Address: 1859 RIVER QUEEN LN, STEAMBOAT	Property Use: VAC
Owner: SUNSHINE STEAMBOAT, LLC	Lot Area: 0
Parcel ID: 313400003	Year Built: 0
Zoning: TOWN	Book Page: SPECIAL

TB-21-755

**RCRBD Record Set
T.A.**

The following items and questions below will need to be addressed prior to the Building Permit being issued. Please make all necessary corrections and resubmit the corrected plans for review. Corrections shall be “ballooned” if made on the plans and a narrative that specifically references the items on this list shall be included with the resubmittal.

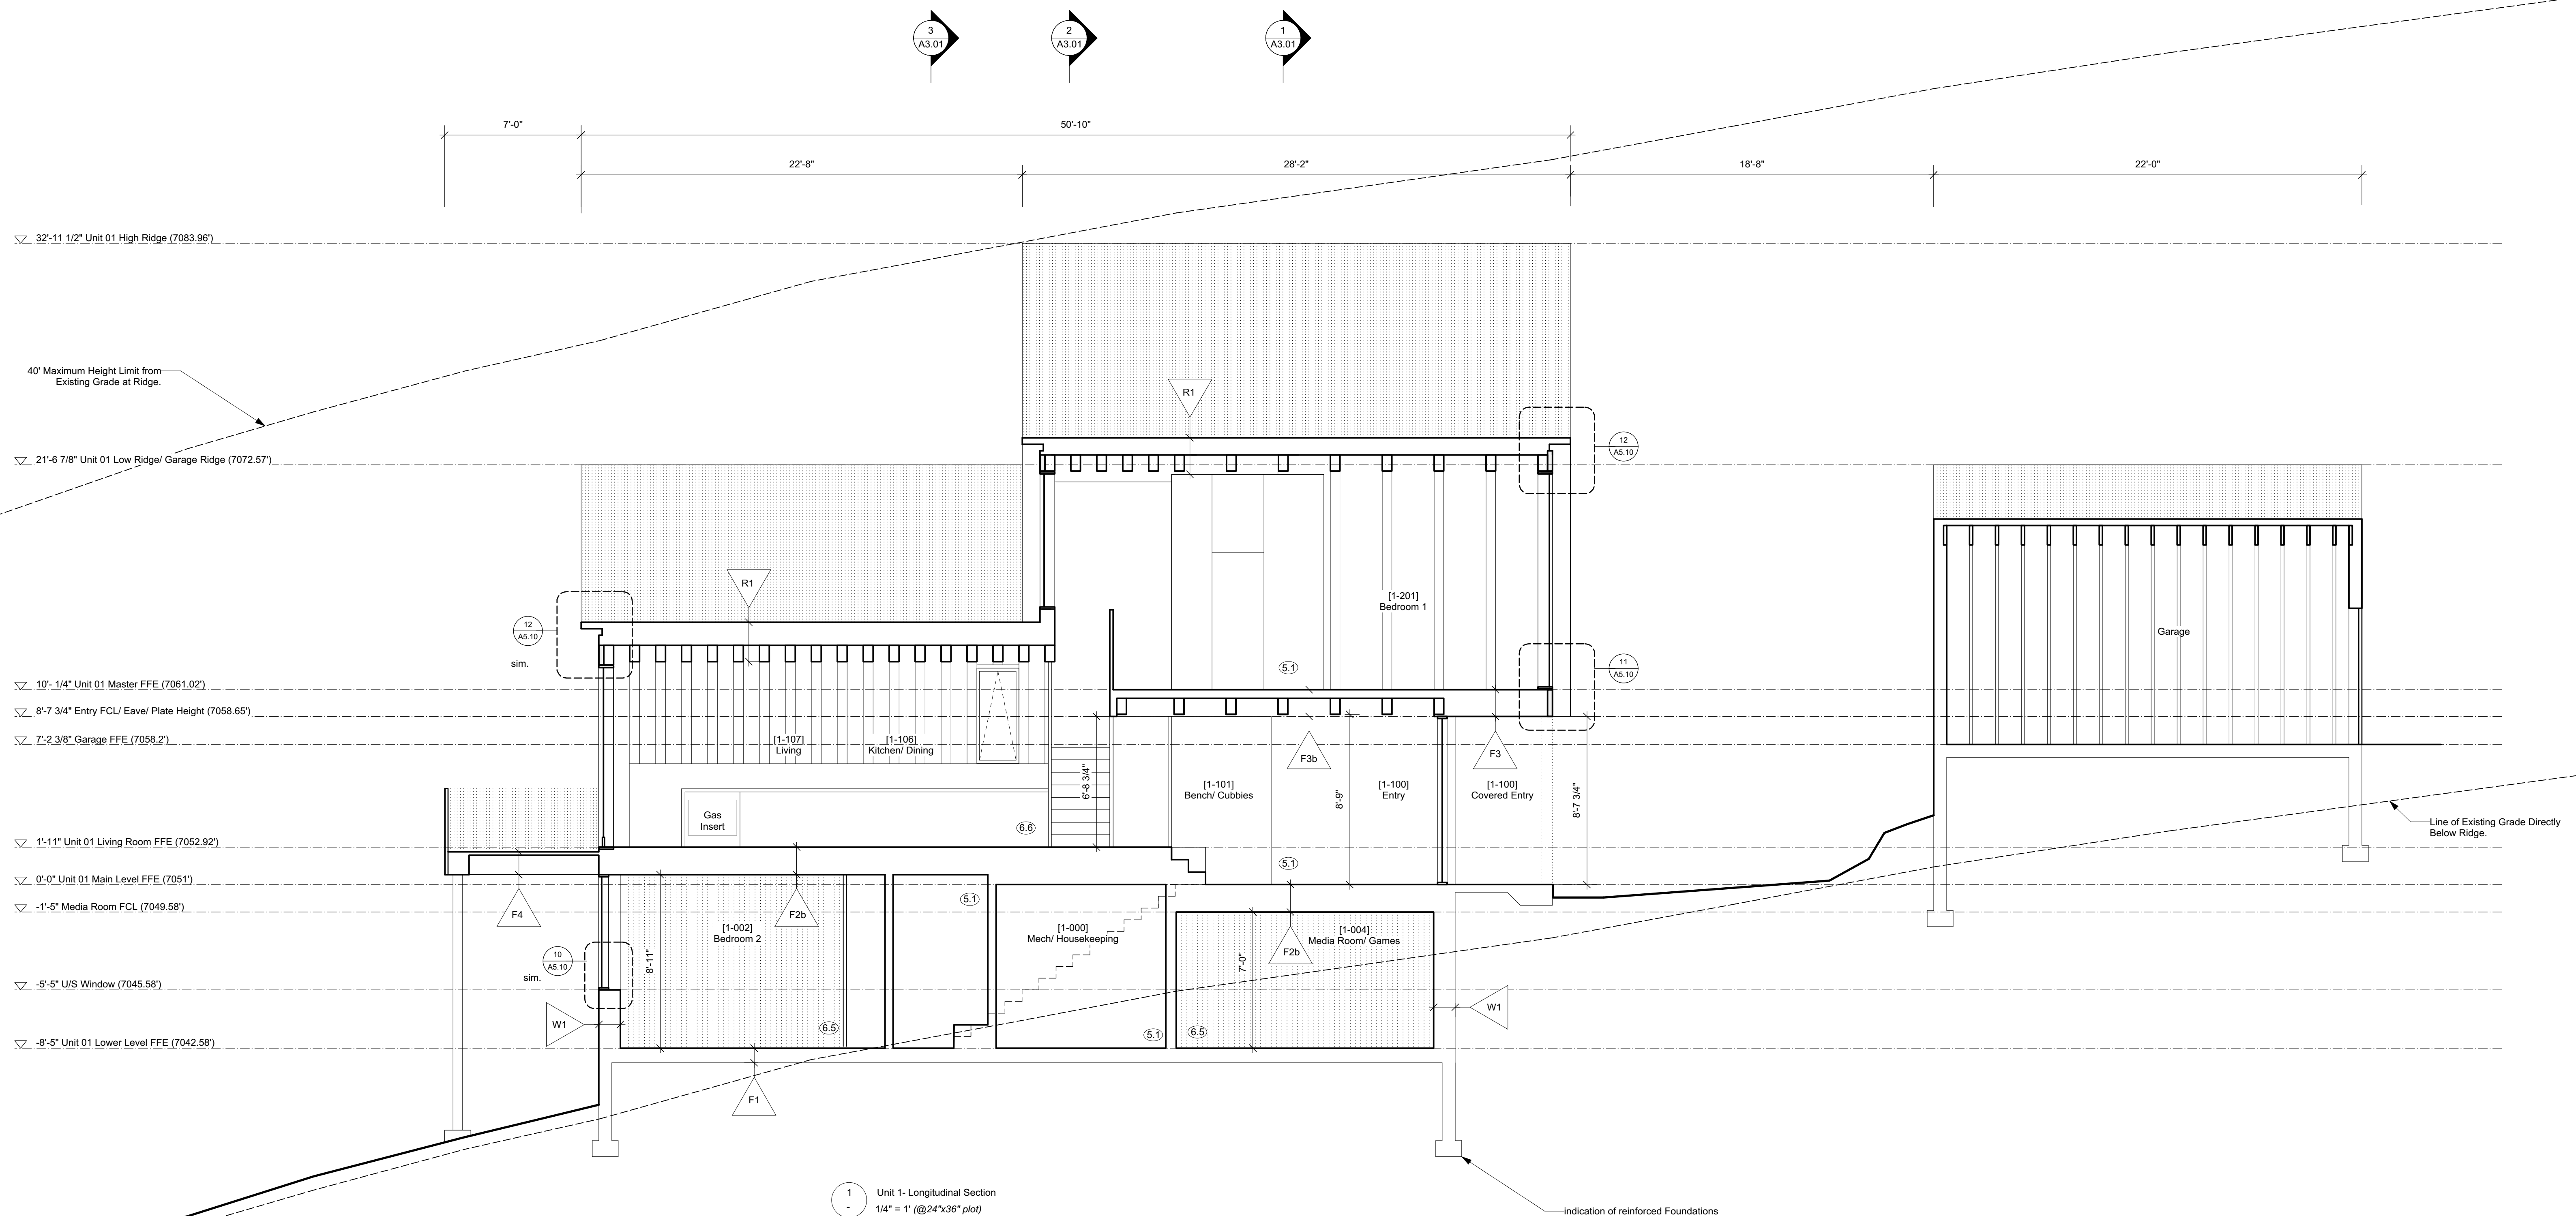
3. The insulation values appear out of compliance for Zone 7. Building sections for this project shall include the information per prescriptive energy path as per attached Energy Code Compliance chart for reference below

for values and distances. Building sections should incorporate all items and corrected to show following specific items:

- a. While 1/A3.04 shows F-1 with R-21 insulation under Entry, however a minimum of R-10 insulation as required from the top of concrete downward 48" (vertical and/or horizontal) for slab on grade.
- b. Similarly, the garage appears to have similar conditions at slab on grade. Please specify how each element is to be insulated with minimum R-values and attention to minimum distances (if applicable).
